32ND AVENUE (HIGHLANDS CREEK BLVD TO TAH PARKWAY) AT THE AURORA HIGHLANDS

OVERALL SITE PLAN

32ND AVENUE (HIGHLANDS CREEK BLVD TO TAH PARKWAY)
AT THE AURORA HIGHLANDS
GRADING & UTILITY PLAN

TRACT KEY MAP

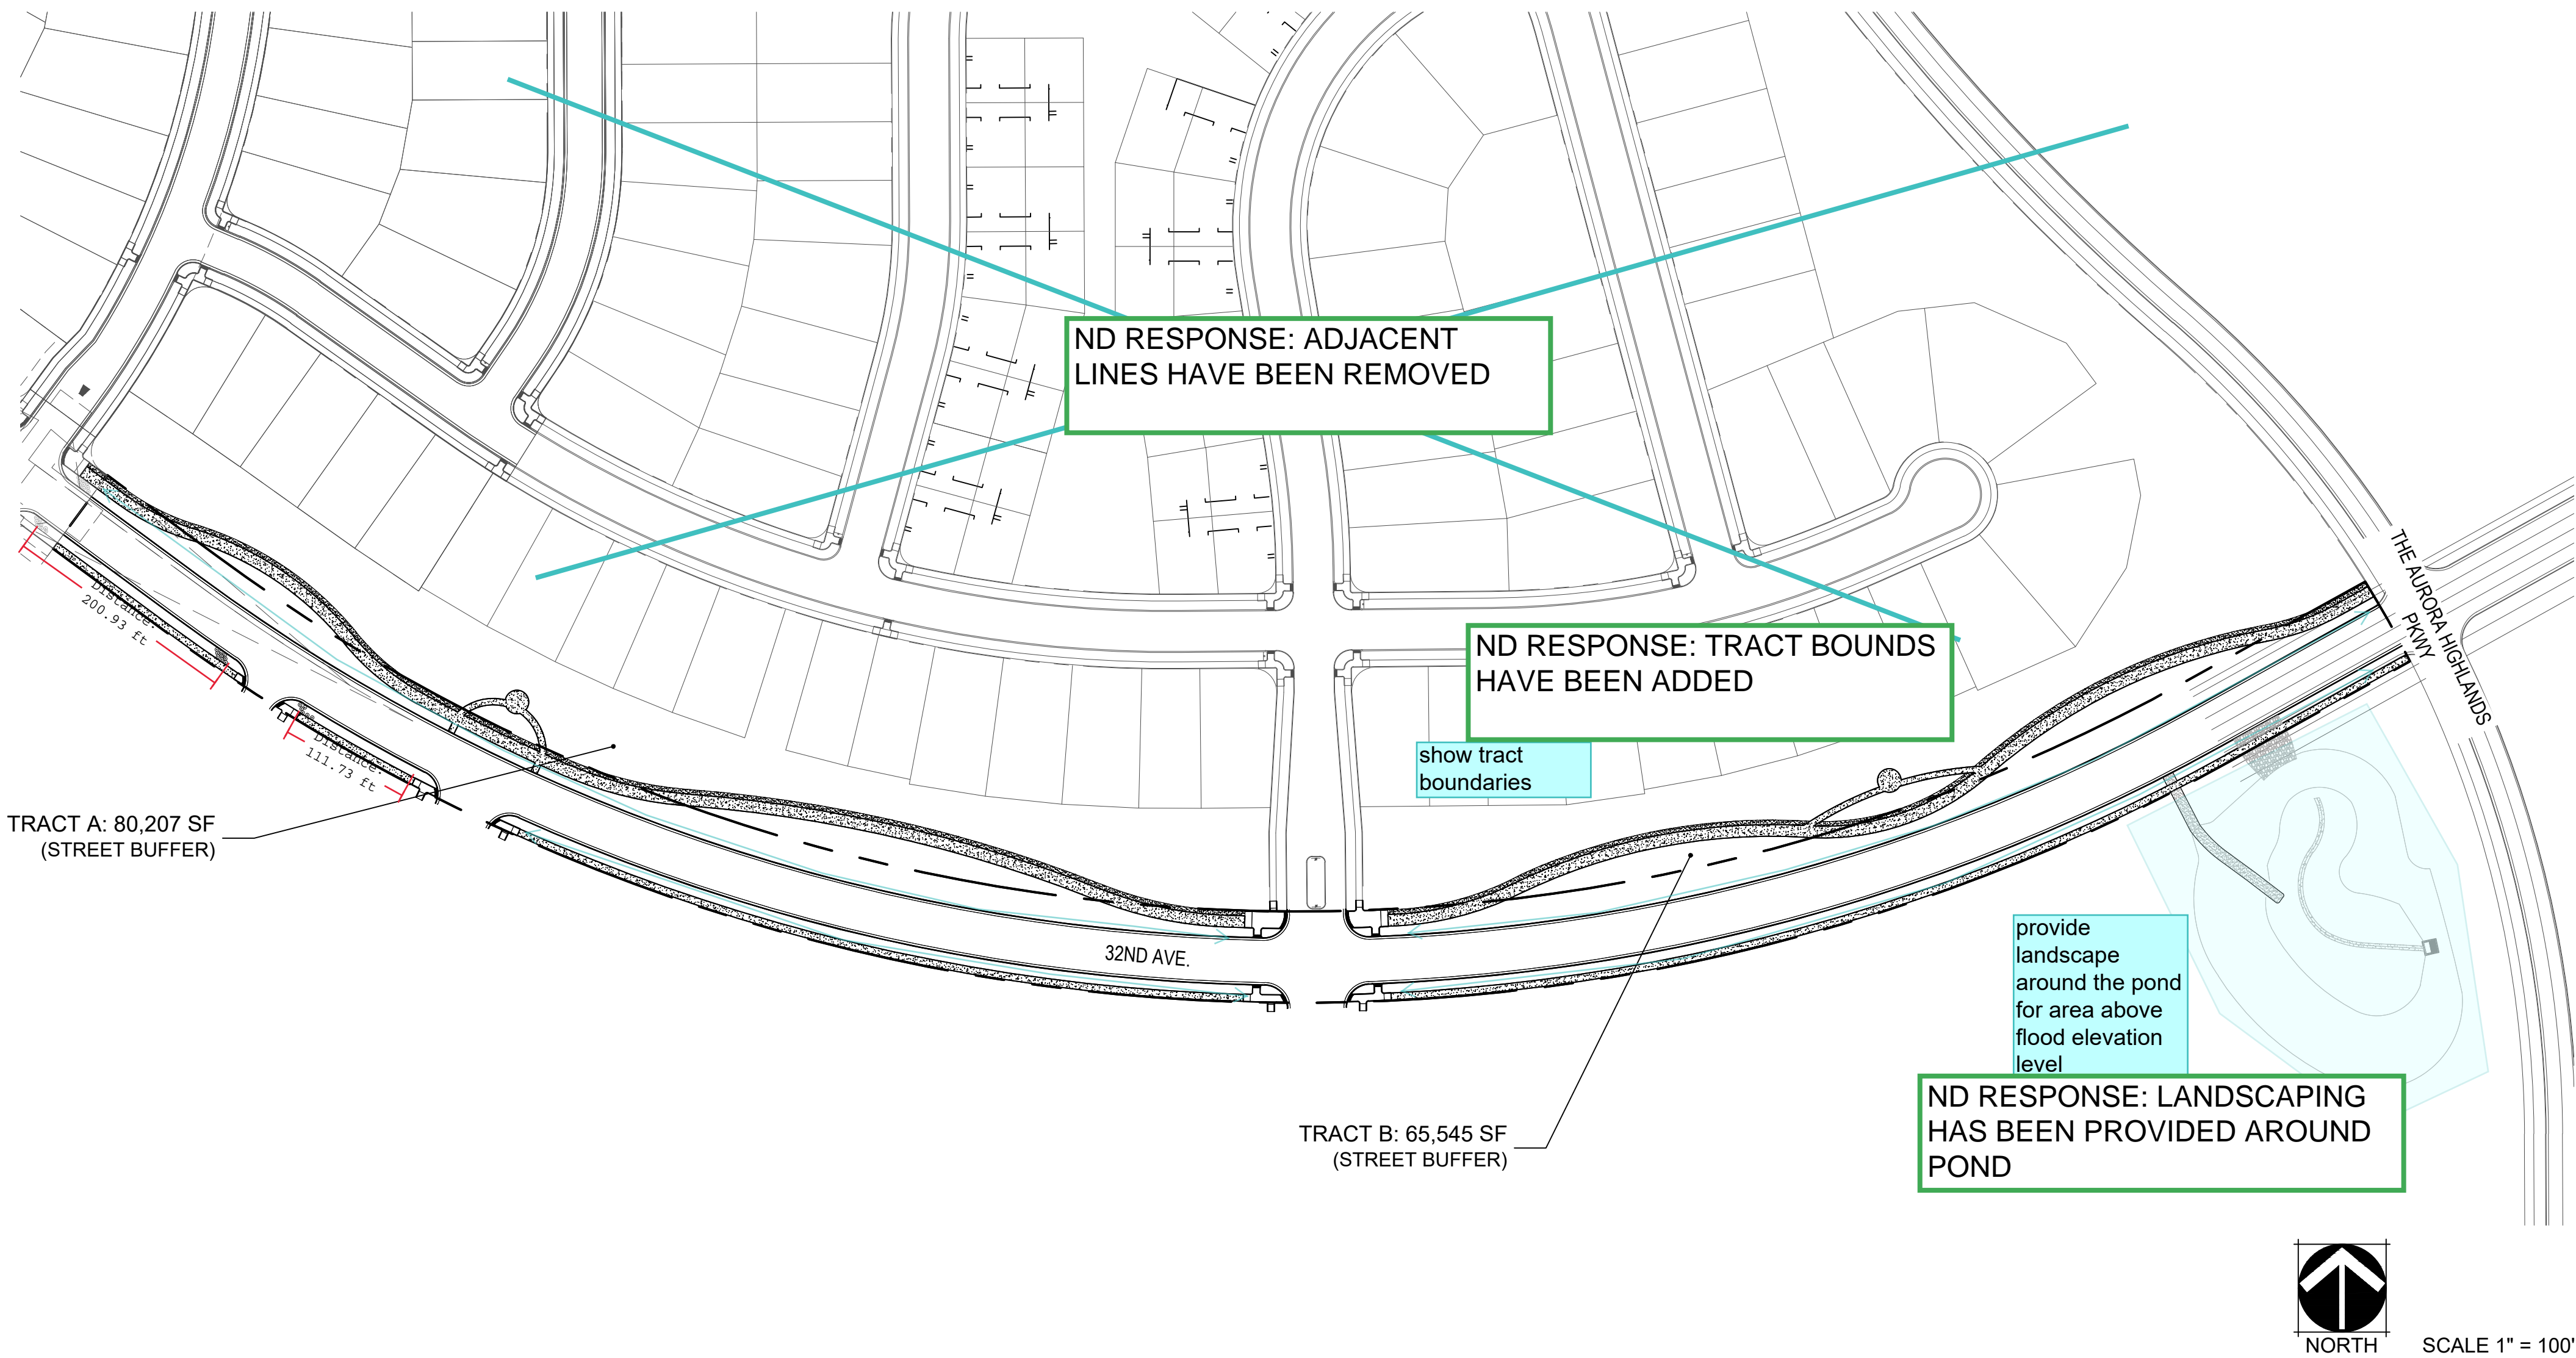
Revise calculations for trees in the curbside landscape. Trees have been set back from intersections where there are no stop signs.

Add note re: COA plantings in sight triangles.
Max plant height 26"

ND RESPONSE: STREET LENGTHS HAVE BEEN ADJUSTED AND THE REQUIRED TREE COUNTS ARE BEING MET

ND RESPONSE: NOTE HAS BEEN ADDED

L2.00 - LANDSCAPE PLAN
SHEET: 16 OF 27

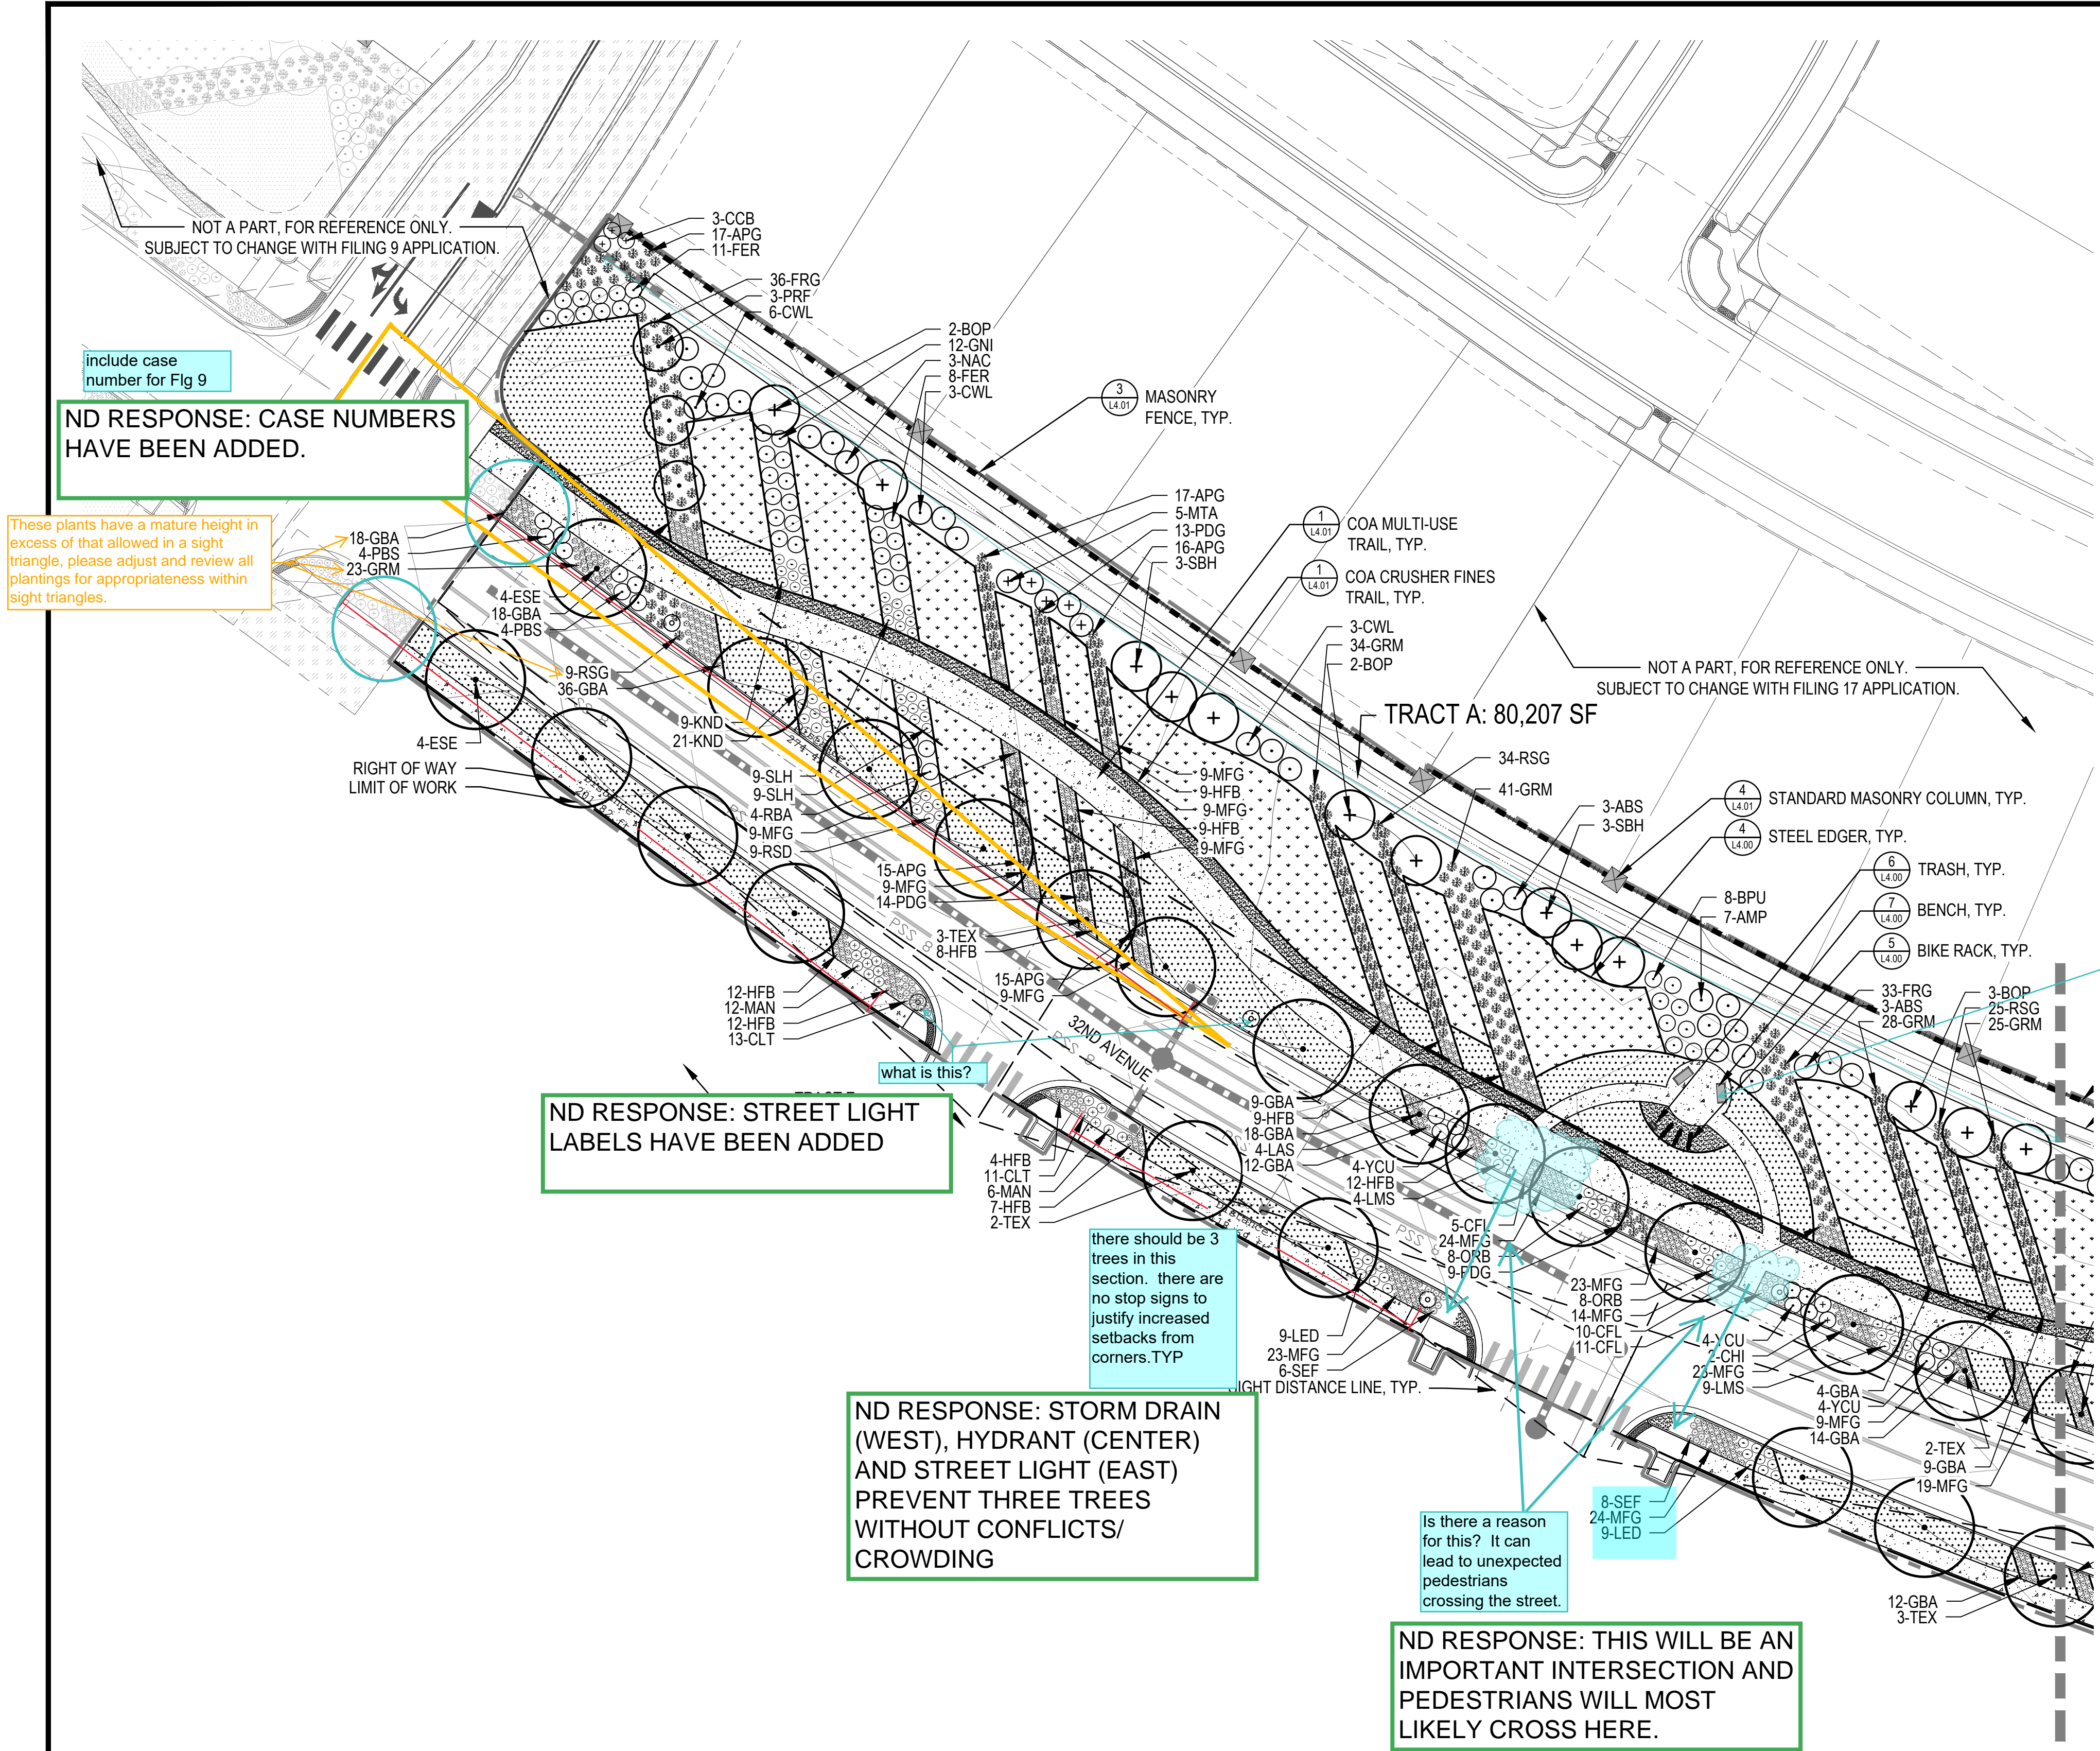
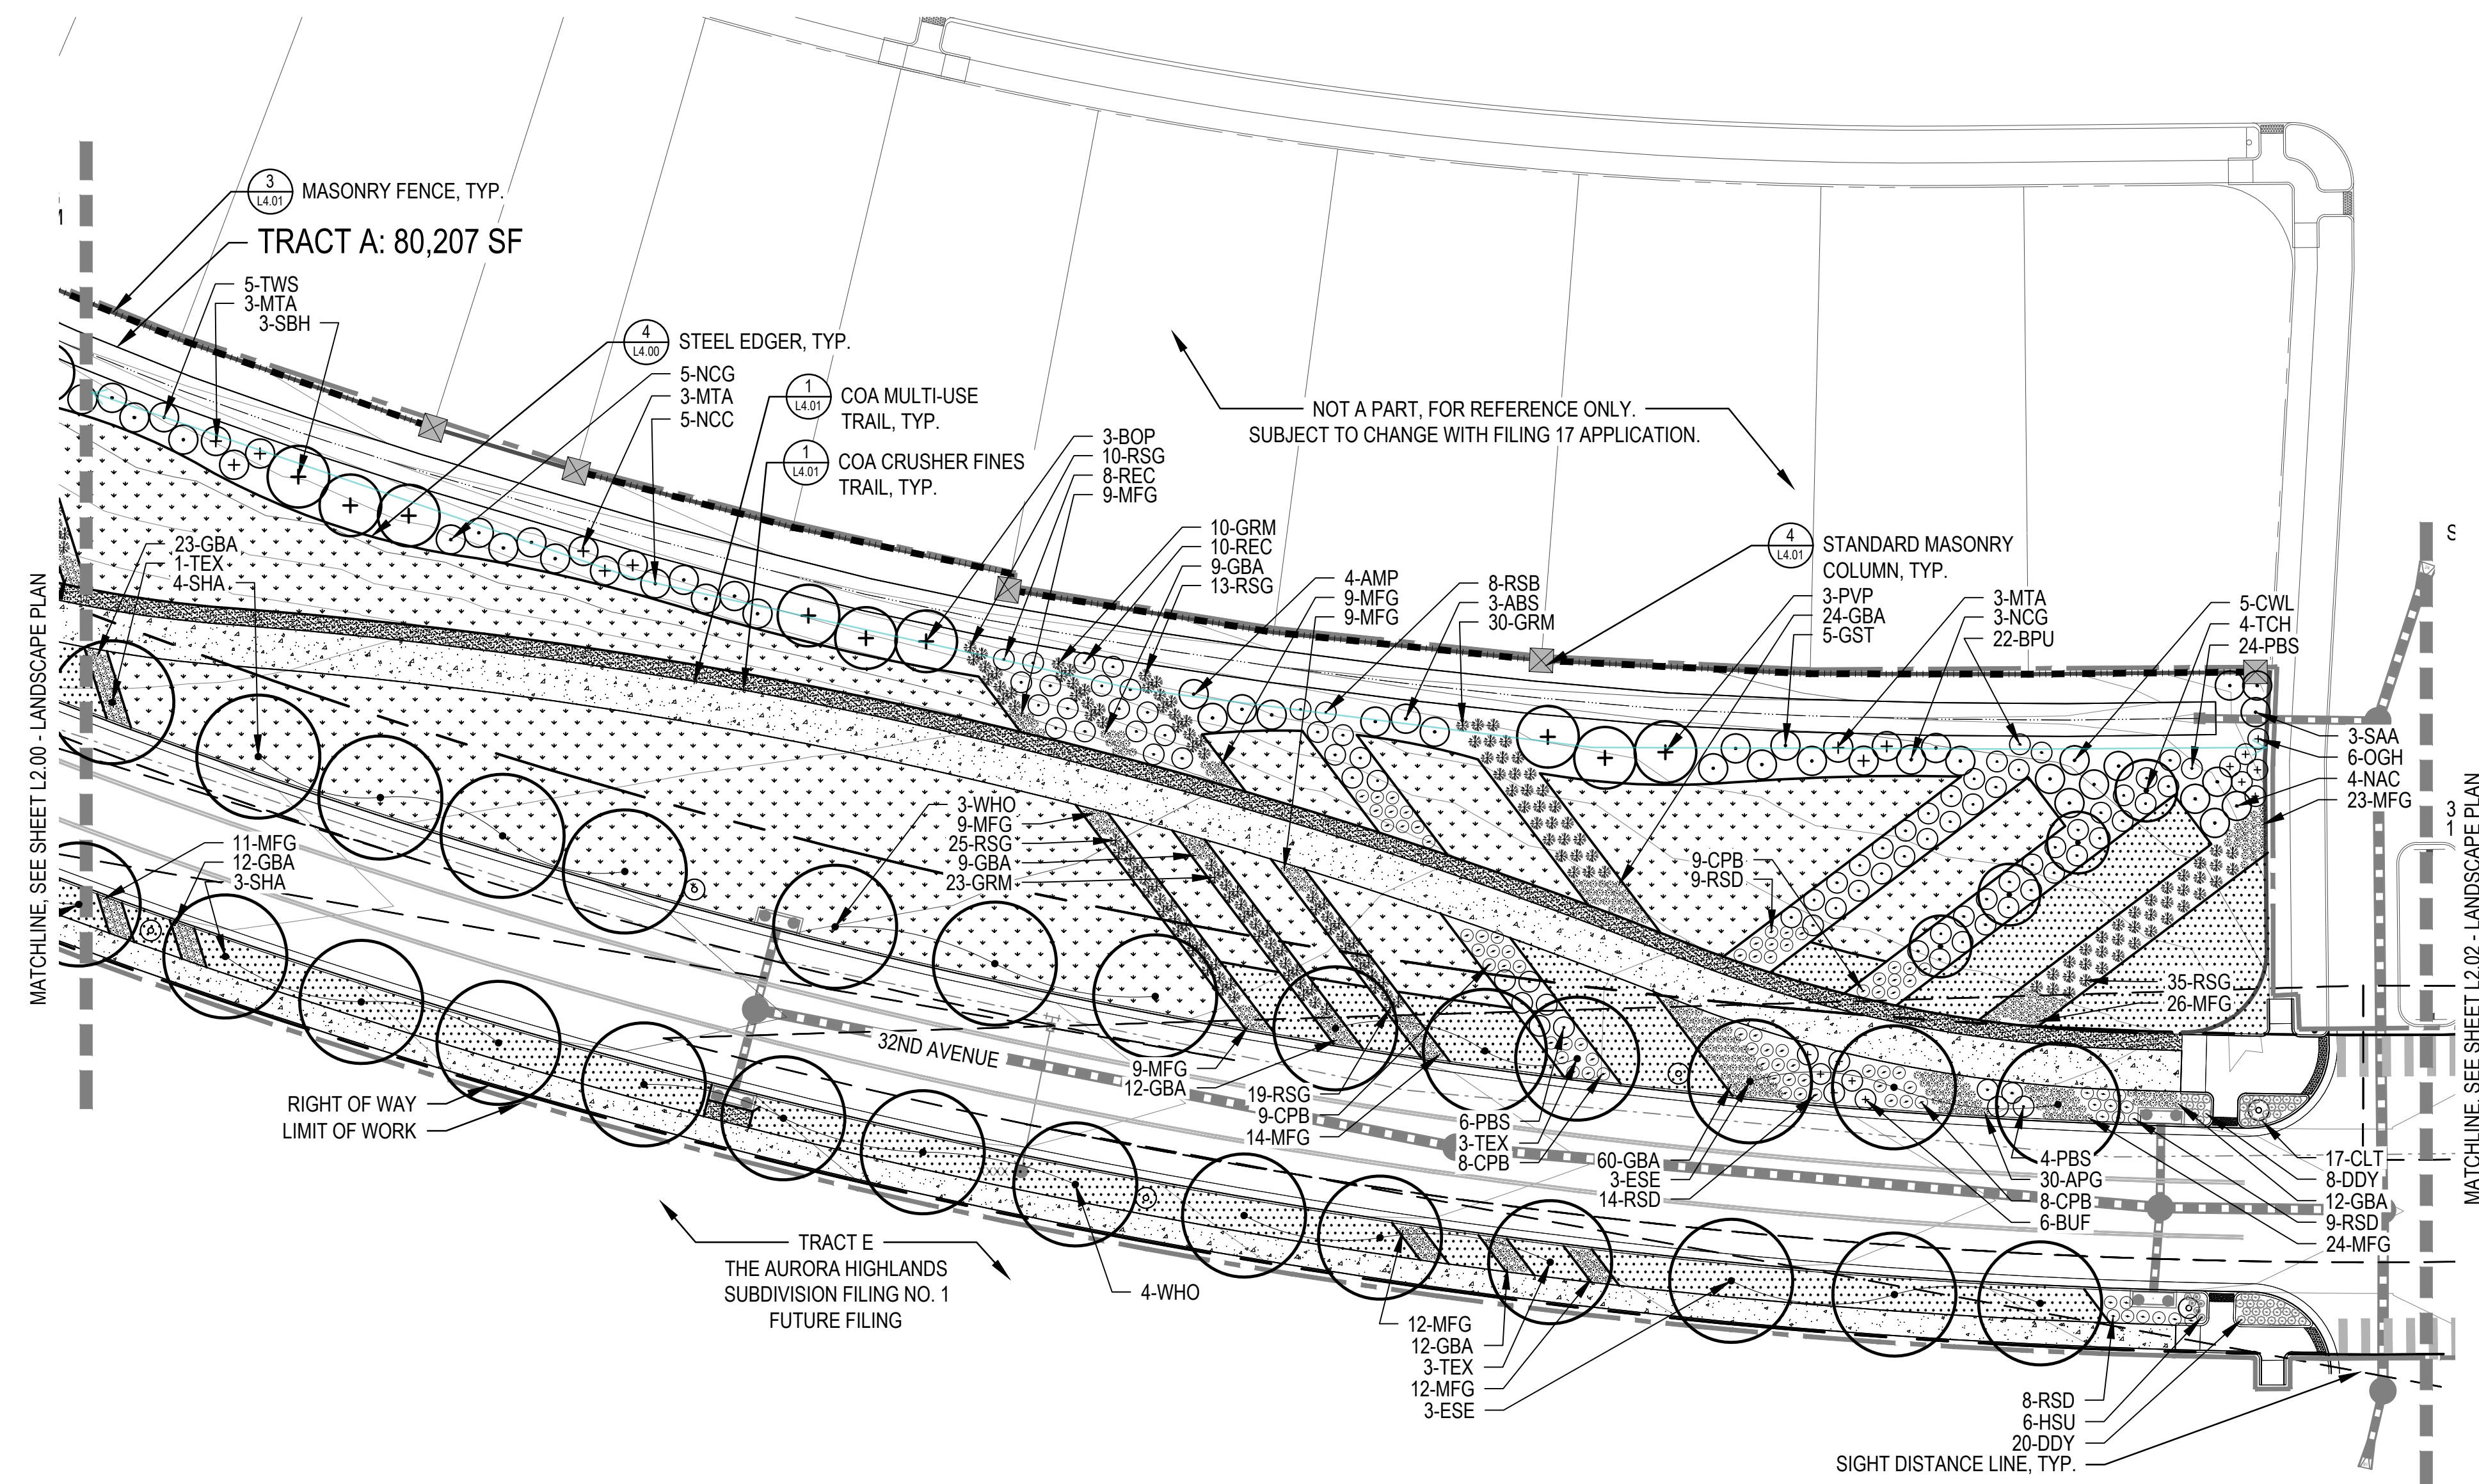
include case number for Fig 9

These plants have a mature height in excess of that allowed in a sight triangle, please adjust and review all plantings for appropriateness within sight triangles.

consider providing shade around the seating area

ND RESPONSE: CASE NUMBERS HAVE BEEN ADDED.

ND RESPONSE: STREET LIGHT LABELS HAVE BEEN ADDED

ND RESPONSE: STORM DRAIN (WEST), HYDRANT (CENTER) AND STREET LIGHT (EAST) PREVENT THREE TREES WITHOUT CONFLICTS/ CROWDING

ND RESPONSE: THIS WILL BE AN IMPORTANT INTERSECTION AND PEDESTRIANS WILL MOST LIKELY CROSS HERE.

ND RESPONSE: NOTED, THANK YOU
